**MONTGOMERY COUNTY PLANNING DEPARTMENT**  
 THE MARYLAND-NATIONAL CAPITAL PARK AND PLANNING COMMISSION

MEMORANDUM

**SUBJECT:** Local Map Amendment No. G-865 "Edgemoor at Arlington North", request for reclassification of 8,342 square feet of land from the R-60 Zone to the TS-R Zone for property known as Part of Lot 31, Block 13, Edgemoor, located at 7425 Arlington Road, Bethesda.

Development Plan Amendment No. 07-3 "Edgemoor at Arlington North" request for an amendment to an approved Local Map amendment No. G-779, 28, 443 square feet of land, zoned TS-R, located at the north east corner of the intersection of Arlington Road and Montgomery Lane, Bethesda.

**PUBLIC USE & ACTIVE PASSIVE RECREATION SPACE EXHIBIT**

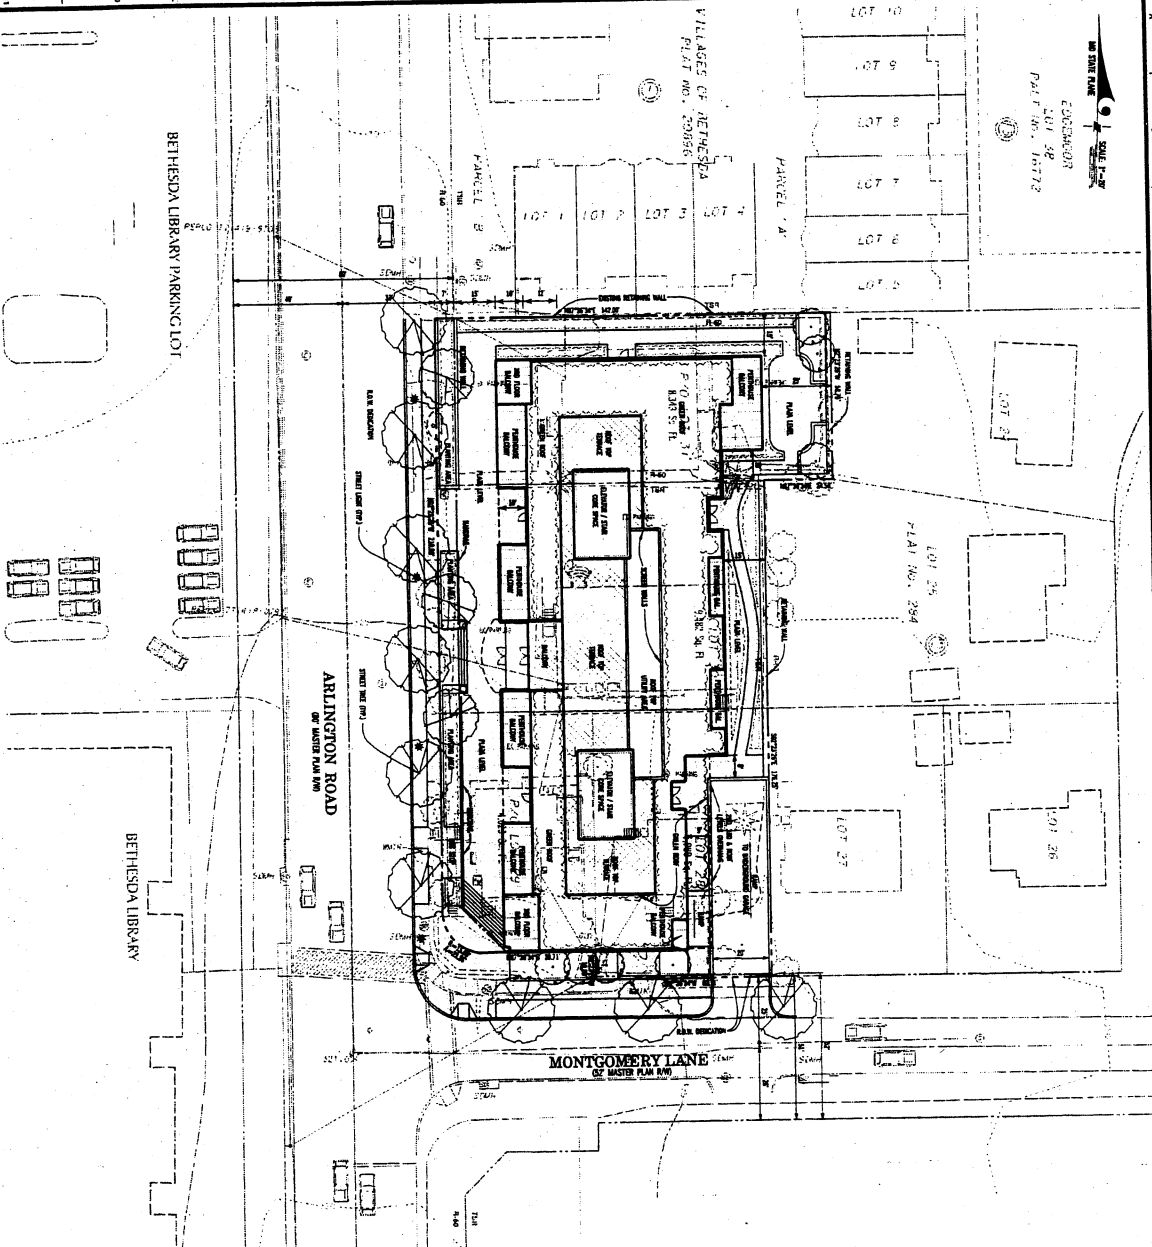
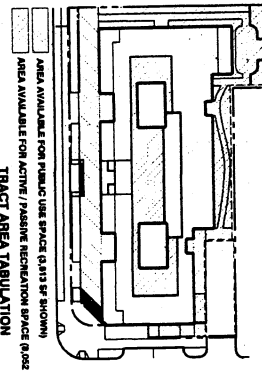
The application implements the sector plan recommendation for the provision of public facilities and amenities. The Development Plan provides for 2,674 Square feet (10%) of area dedicated for public use space and 5,348 square feet (20%) area dedicated for passive recreational space. for a total of 8,022 square feet (30%) of net land area.

**LAND USE PLAN FOR**  
 DEVELOPMENT PLAN AND DEVELOPMENT PLAN AMENDMENT  
**EDGEWOOD AT ARLINGTON NORTH**  
 LOT 26 & PART OF LOTS 25, 26 AND 27, BLOCK 13 OF EDGEWOOD  
 7 BETHESDA DISTRICT  
 MONTGOMERY COUNTY, MARYLAND

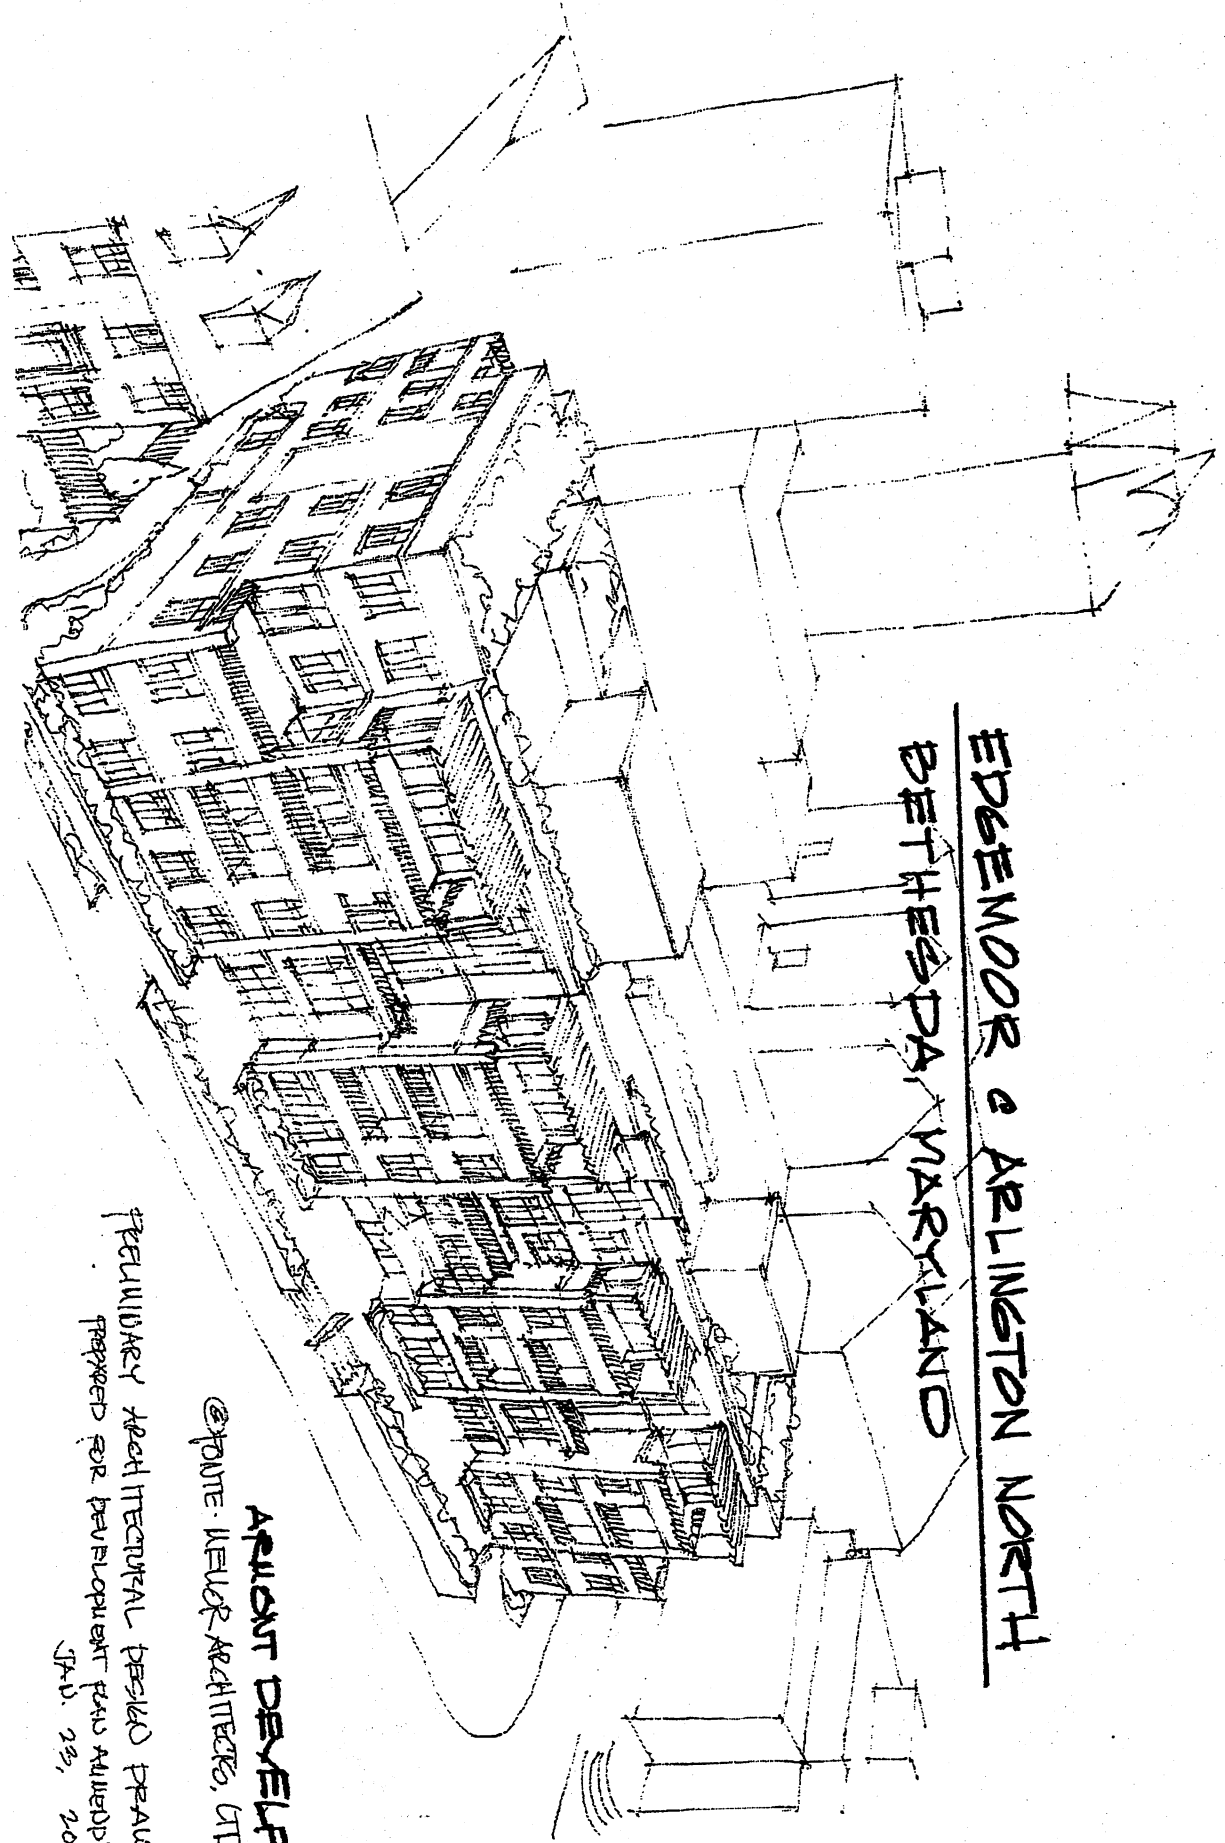
\*The 68,000 SF figure depicted on the site plan is erroneous. The conversion of 1.8 FAR to square footage comes to 68,542 SF.

The proposed development complies with the required development standards of the TS-R Zone as specified in §59-C-8.4. The latest revised plan proposes a maximum height of 48 feet. The proposed building is designed with a 15-foot setback from the Arlington Road right-of-way and 35 feet of height on its façade along the Road, stepping up to 48 feet of height at the penthouse level that is set back 10 feet from the building façade in compliance with the Sector Plan's specific recommendation for developments along Arlington Road for a low-rise, residential scale development. The proposed maximum 48 feet of building height is also very similar with the building height approved by the County Council (G-779) in 2001 for a proposed development on a portion of the subject site.
